Project	IEEE 802.16 Broadband Wireless Access Working Group < http://ieee802.org/16 >		
Title	Closed-Loop Precoding for STC		
Date Submitted	2004-11-04		
Source(s)	Mattias Wennström, Popovic Huawei	Branislav	Voice: +46-8-4770803 mattias.wennstrom@huawei.com
	PO Box 54 SE-164 94 Kista Sweden		
Re:	Contribution on comments to IEEE P802.16e/D5		
Abstract	Closed loop STC precoding to improve performance with limited feedback		
Purpose	Discussion and Adoption		
Notice	This document has been prepared to assist IEEE 802.16. It is offered as a basis for discussion and is not binding on the contributing individual(s) or organization(s). The material in this document is subject to change in form and content after further study. The contributor(s) reserve(s) the right to add, amend or withdraw material contained herein.		
Release	The contributor grants a free, irrevocable license to the IEEE to incorporate material contained in this contribution, and any modifications thereof, in the creation of an IEEE Standards publication; to copyright in the IEEE's name any IEEE Standards publication even though it may include portions of this contribution; and at the IEEE's sole discretion to permit othe

Figure 1 Performances of closed loop precoded STC with several different feedback schemes on quasi-static flat Rayleigh fading channel.

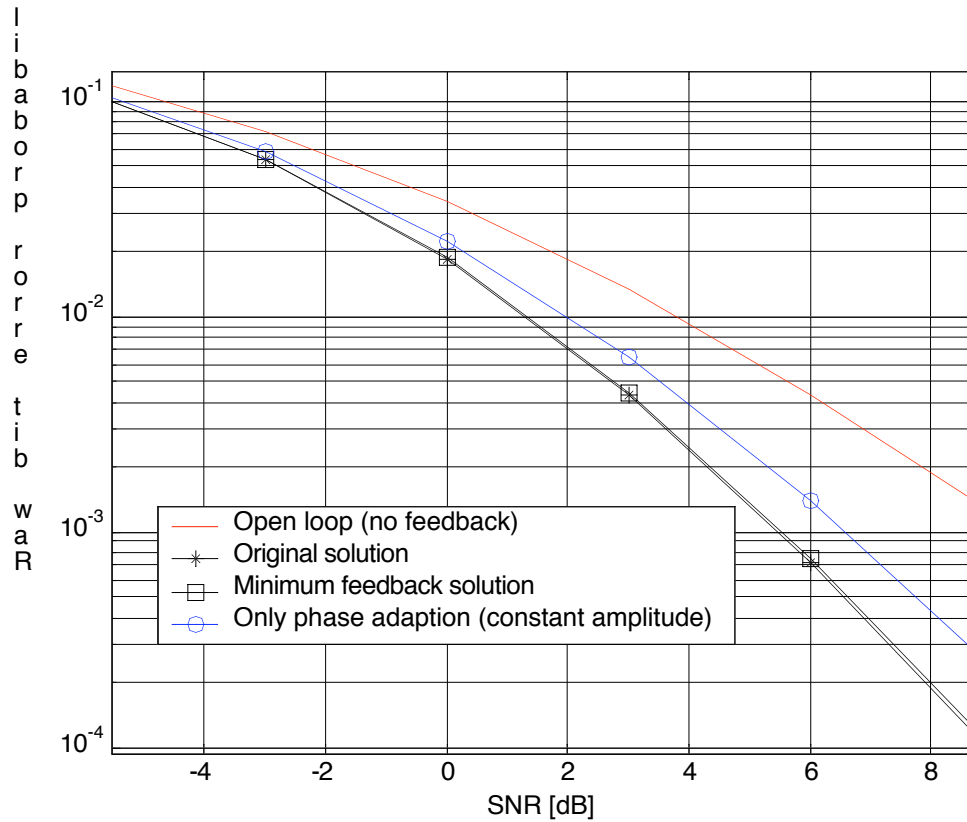
To compare the performances of the current precoding solution with the other solutions with reduced feedback discussed above, for several discussed feedback configuration we have performed Monte-Carlo evaluations of the raw bit error rate as function of the received SNR. We have assumed BPSK modulation in quasi-static i.i.d Rayleigh fading channel with two receive antennas. The results can be seen in [Figure 1](#)~~Figure 1~~.

As it can be seen in [Figure 1](#)~~Figure 1~~, the minimum feedback solution results in negligible raw bit error rate degradation compared to the current STC precoding solution. On the other side, as the current solution requires 4 times more feedback data than the minimized feedback solution, its performances in terms of coded bit error rate and block error rate will be significantly worse than for the minimum feedback solution.

To further reduce, i.e. minimize the amount of feedback, with almost negligible loss in the received SNR (as it is shown by simulations), we propose to quantize the phase information to 4 values. In that way, 2 bits for the phase information are required, and with the 3 bits for the amplitude information, we come up to the total of 5 required feedback bits for each update of the precoding weights for all 4 antennas. The amount of feedback is thus minimized to be contained in a single feedback payload entity of 5 bits. We shall refer to this solution as “minimum feedback” solution.
